Access Compliance Report

Public Rights-of-Way

Intersection ID: 49932	Main Street: WOBURN_RD	Cross Street: PAXTON_RUN_RD	Location: SW
ADA ID: C5F4B78D67E9	Ramp Type: Perp	Initial Pass/Fail: Fail	Overall Compliance: No
Severity Score: 13.75			
Codes/Mitigation Info/Possible Solution		Field Measurements/Component Compliance

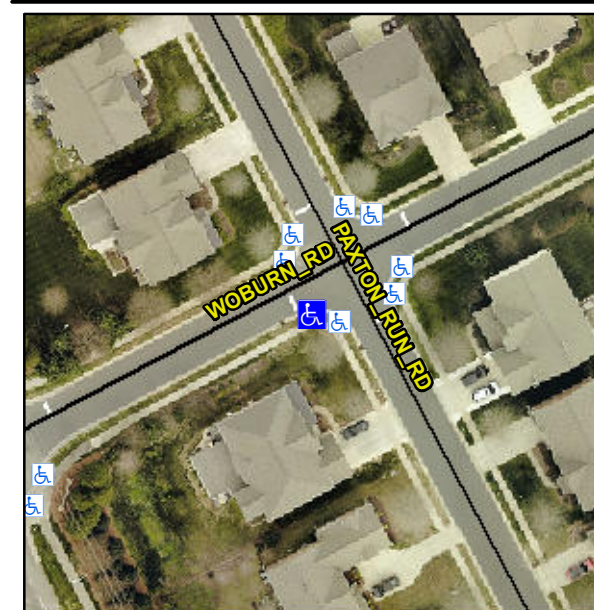
R304.2.2, R304.5.3

Compliance	Description	Data	Compliance	Description	Data
N/A	Ramp Length (in)	47.0	No	Ramp Slope (%)	8.5
Yes	Ramp Width (in)	48.0	No	Ramp XSlope (%)	3.3
N/A	Flare Type LT	N/A	N/A	Flare Type RT	N/A
N/A	Flare Slope LT (%)	N/A	N/A	Flare Slope RT (%)	N/A
N/A	Flare Traversable LT?	N/A	N/A	Flare Traversable RT?	N/A
N/A	Landing Length (in)	N/A	N/A	DWS Provided?	N/A
N/A	Landing Width (in)	N/A	N/A	DWS Contrast?	N/A
N/A	Landing Slope (%)	N/A	N/A	DWS Length (in)	N/A
N/A	Landing X Slope (%)	N/A	N/A	DWS Full Width?	N/A
N/A	Landing Curb? (Y/N)	N/A	N/A	DWS Offset (in)	N/A
N/A	Shared Landing?	N/A			
N/A	Gutter Ponding?	N/A	N/A	Gutter Slope (%)	N/A
N/A	Gutter Lip Ht (in)	N/A	N/A	Gutter X Slope (%)	N/A
N/A	Painted X Walk1?	No	N/A	Painted X Walk2?	N/A
	X Walk 1 Direction	To NE		X Walk 2 Direction	N/A
N/A	X Walk 1 Width (in)	N/A	N/A	X Walk 2 Width (in)	N/A
	X Walk 1 Slope (%)	3.6		X Walk 2 Slope (%)	N/A
	X Walk 1 X Slope (%)	1.6		X Walk 2 X Slope (%)	N/A

Remove & Replace Entire Ramp.
